HISTORIC AND DESIGN REVIEW COMMISSION

2018-409

1011 BROADWAY

Construction of a five story, mixed-use structure

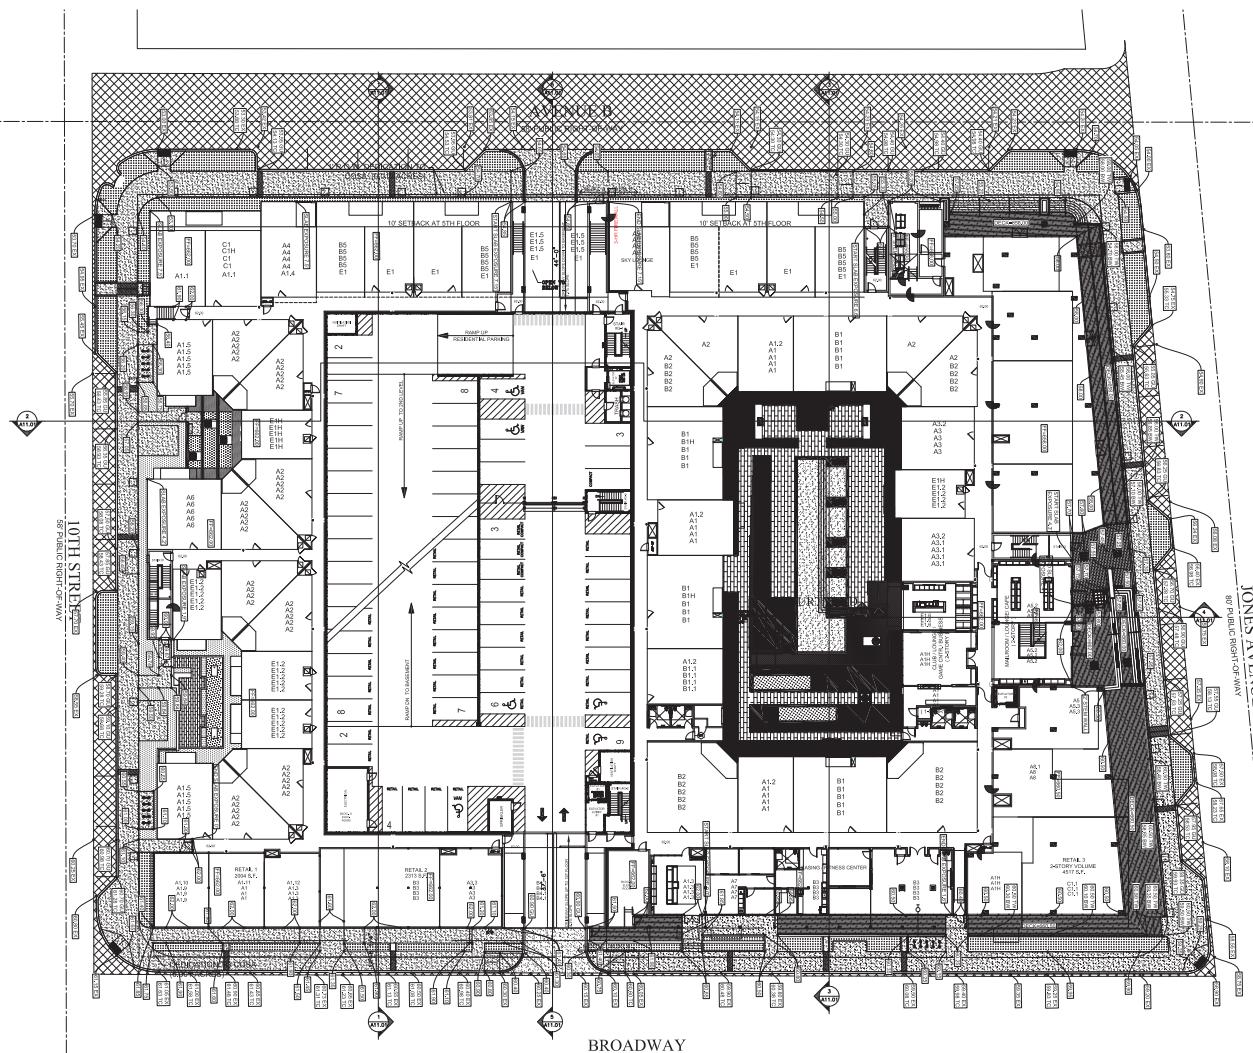
COMMENTS/CONCERNS: PM: OVERVIEW OF PROJECT, GENERAL PROGRAM
AND DESIGN, CF: QUESTIONS REGARDING BRICK FAÇADE. (BRICK ONLY
EXTENDS HALF OF THE BROADWAY FAÇADE). MG: COMMENTS ON
FAÇADE ARRANGEMENT, BALCONIES, PARKING GARAGE, FAÇADE BREAKS
DO A GOOD JOB AT DECODING SCALE. (EL A LITTLE MORE ARTICULATION
WOULD BE NICE ON THE BROADWAY FAÇADE. MG: IF: CURB CUT
BEING REMOVED FROM BROADWAY MAY BE MOST APPROPRIATE. LOCATION
IN BLOCK IS BETTER THAN AT CORNER.

CAN BRICK ARTICULATION BE ADDED TO OTHER FACADES?
